Re: Nine Mile Point Unit 1
Docket No. 50-220
DPR-63

NINE MILE POINT UNIT 1

REACTOR VESSEL MATERIAL

SURVEILLANCE PROGRAM

FIGURE 1
 NINE MILE POINT UNIT
 REACTOR VESSEL

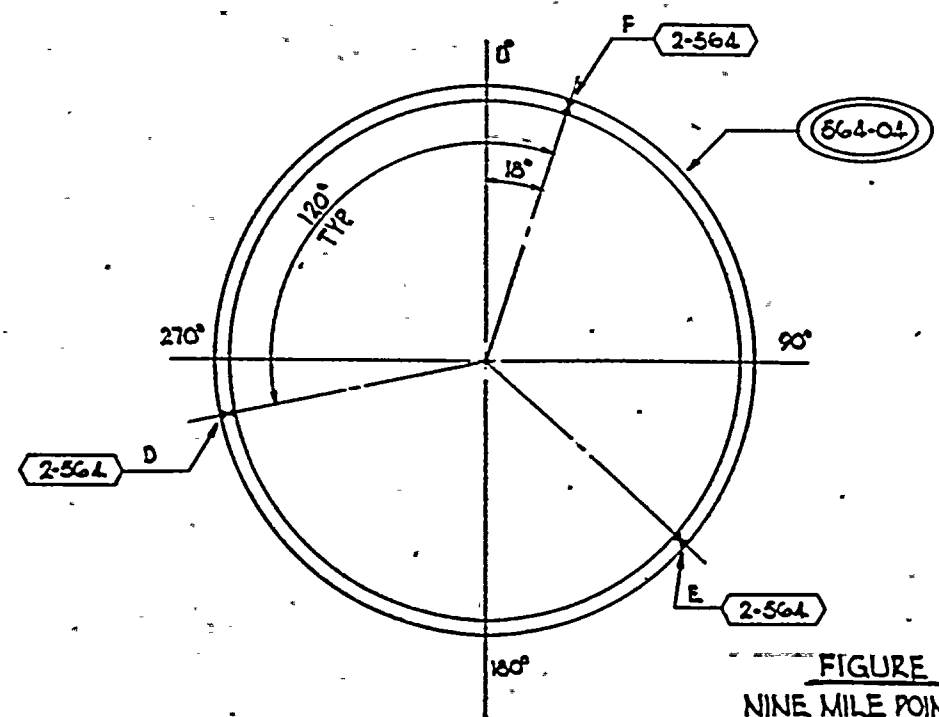
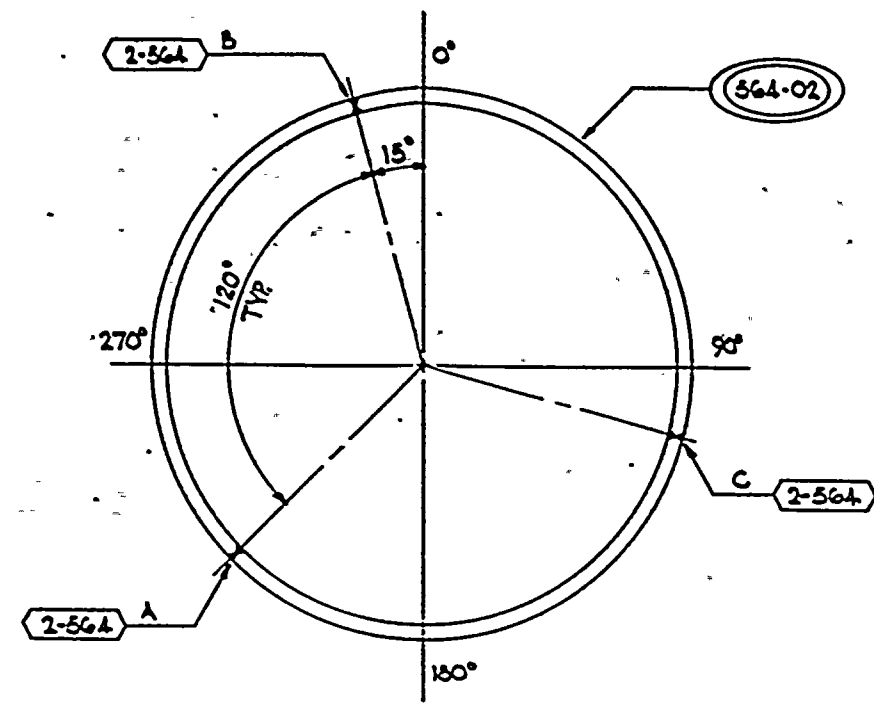
- a. Provide a sketch of the reactor vessel showing all materials, including welds, in the beltline region* and provide an identification number for each material.

- a. Figure 1 attached shows plate material and welds in the beltline region of Nine Mile Point Unit 1 reactor vessel. Vessel piece no. 564-02 contains welds 2-564 A, B, C. Piece no. 564-04 contains welds 2-564 D, E. F. Weld 3-564 joins piece nos. 564-02 and 564-04.
